UNITED STATES PATENT AND TRADEMARK OFFICE

10/822,070

Office Action Summary

DUBE ET AL.

ATTACHMENT 1

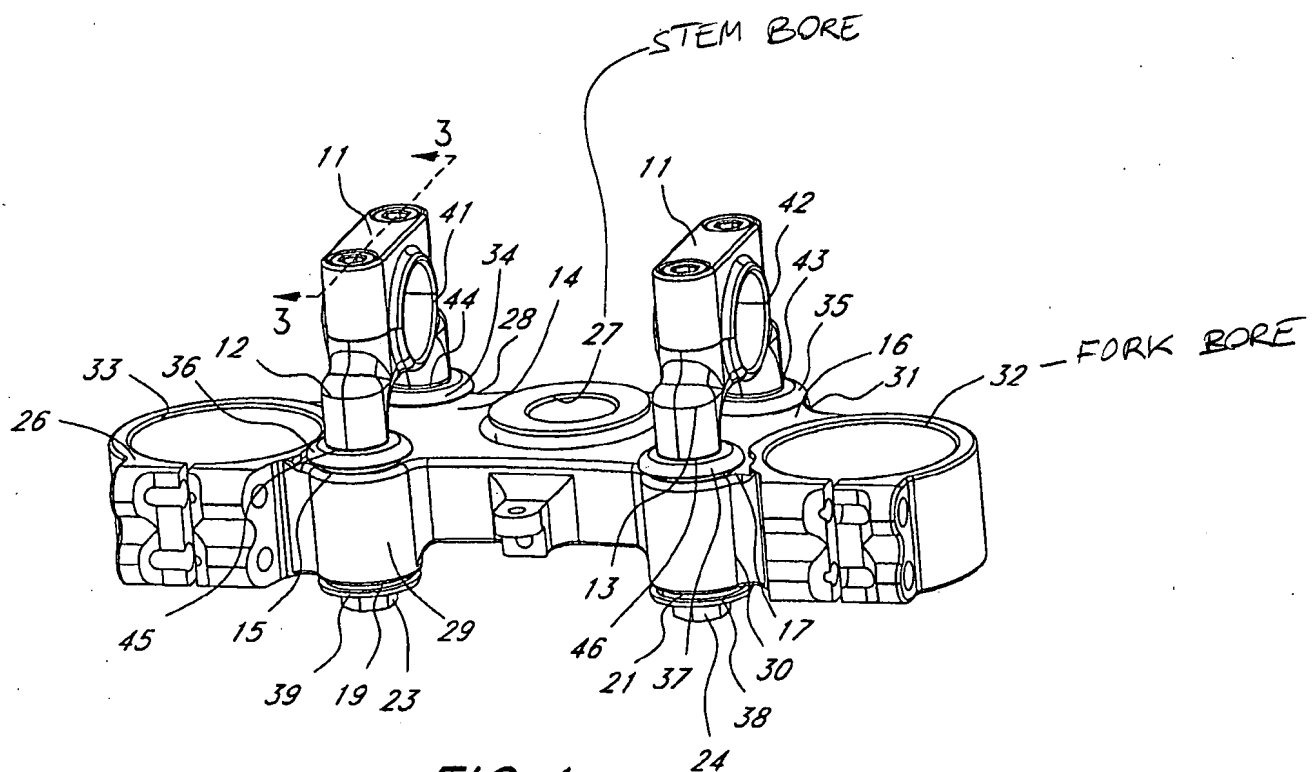
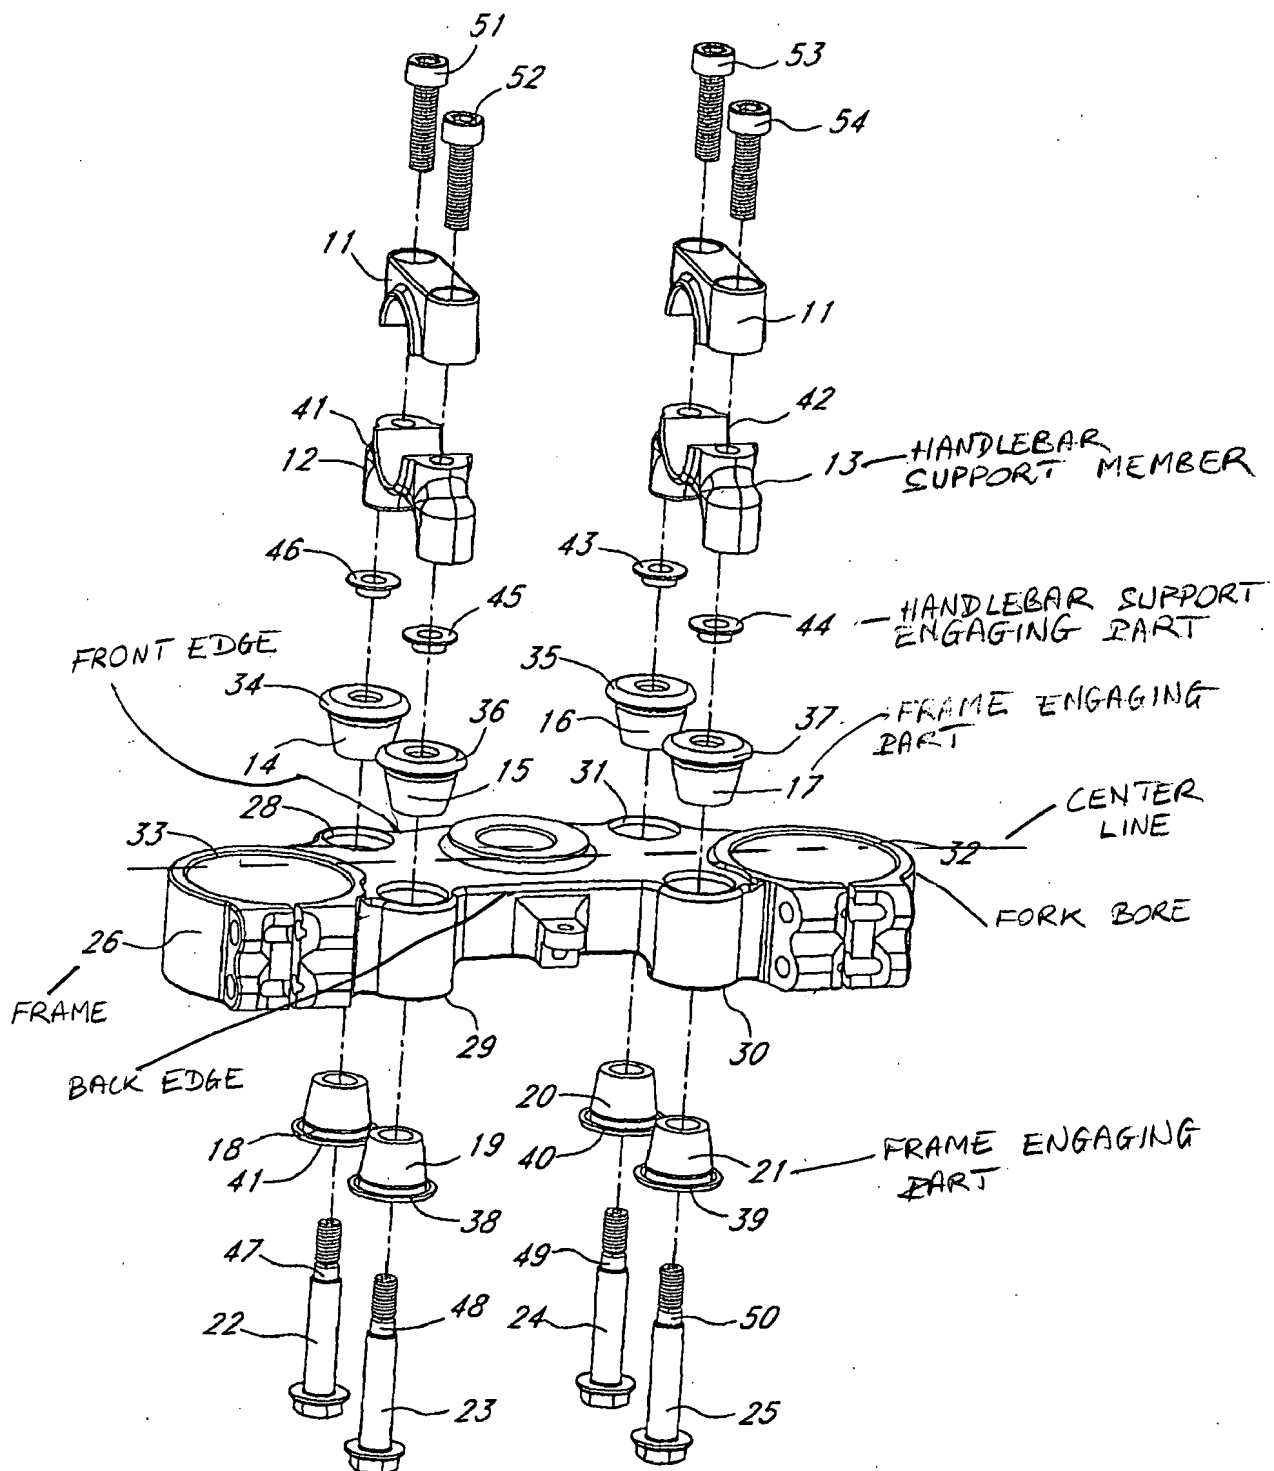
a frame member 26 (see Attachment 1 hereinafter "Att. 1") having a perimeter that comprises a front edge (Att. 1) and a back edge (Att. 1) and having a centerline (Att. 1) between said front and said back edges (Att. 1), comprising,

one or more fork member bores 32, 33 adapted to receive said fork member,
one or more steering stem bores 27 adapted to receive said steering stem;
one or more handlebar support members 11-13 adapted to support said handlebar 10; and
one or more means 22-25 to selectively maintain said handlebar support member 11-13 in one or more selectable positions;

wherein, said frame member 26 has one or more frame engaging parts 14-21 that are adapted to engage, at said selectable positions, one or more handlebar support engaging parts 43-46 provided on said handlebar support member 11-13, and wherein at least two of said selectable positions are inherently between said front edge and said centerline, and at least two of said selectable positions are between said back edge and said centerline.

Regarding Claim 2, at least one of said means to selectively maintain said handlebar support member 11-13 comprises, two or more bolts 22-25 that are each adapted to pass through bolt bores 28 and unnumbered (FIG. 3, Att. 1) provided in said handlebar support member 11-13 and said frame member 26.

one or more means 22-25, to selectively maintain said handlebar support member 11-13 in one or more of said selectable positions, comprising, two or more bolts 22-25 each adapted to pass through bolt bores 28 (FIG. 3, Att. 1) provided in said handlebar support member 11-13 and said frame member 26;

ATTACHMENT 2

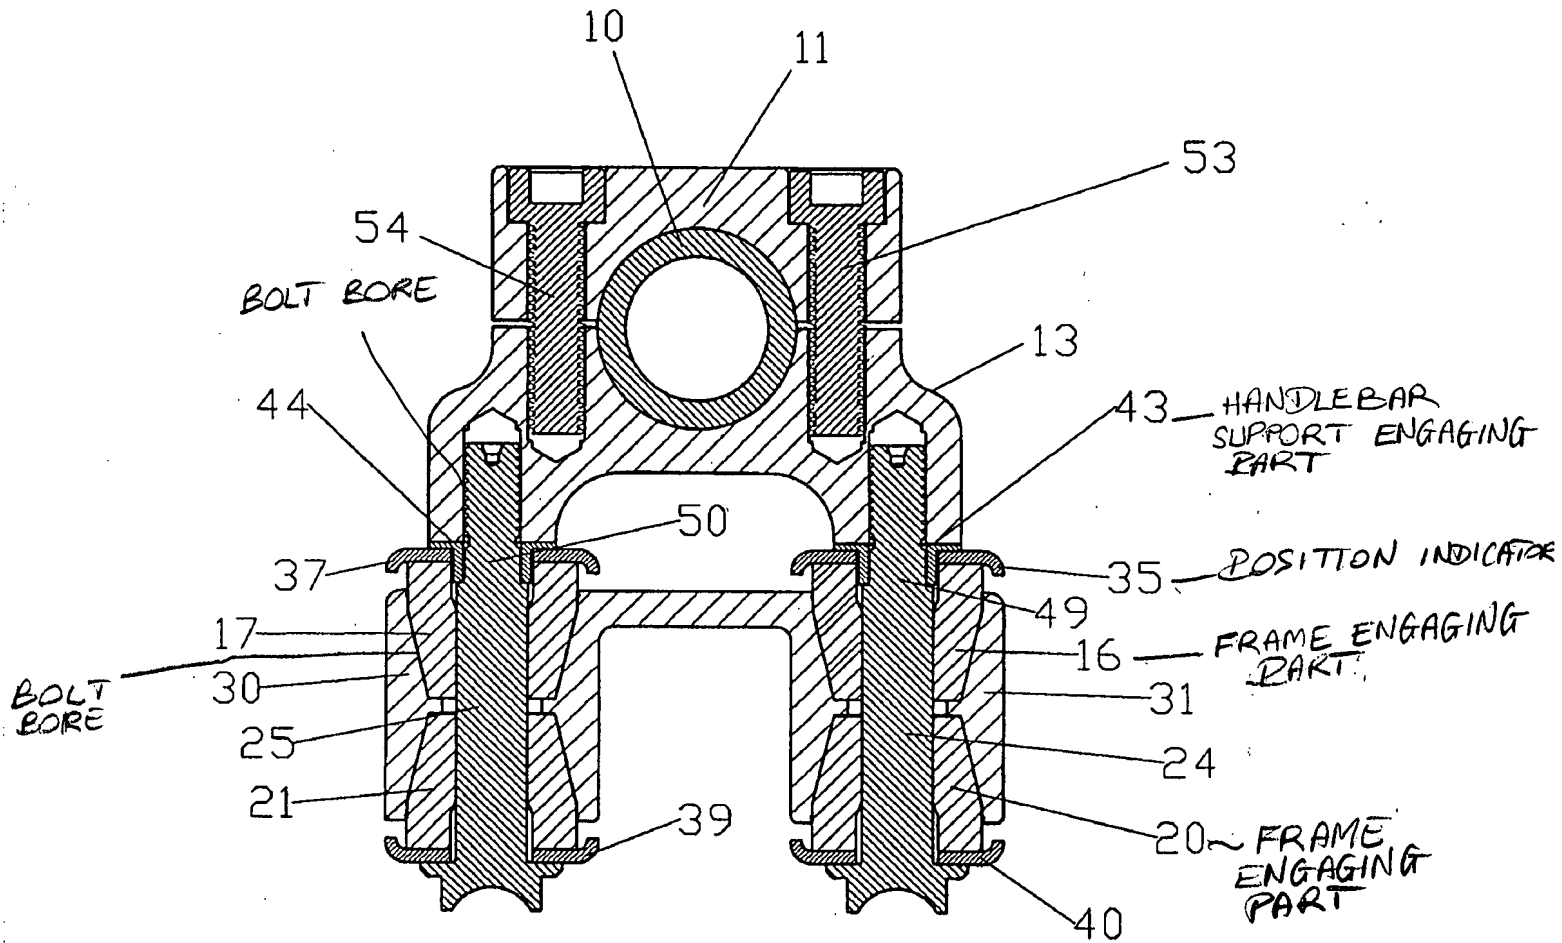
Regarding Claim 11, one or more of said means 44 to selectively change said angle of said steering stem 46 comprises, a steering angle member 44 (FIG. 4), having an offset bore (unnumbered, see FIG. 3 of Att. 2) through said inset member 44 adapted to receive said steering stem 46, that is adapted to be removably fixed in said steering stem bore 56, 82.
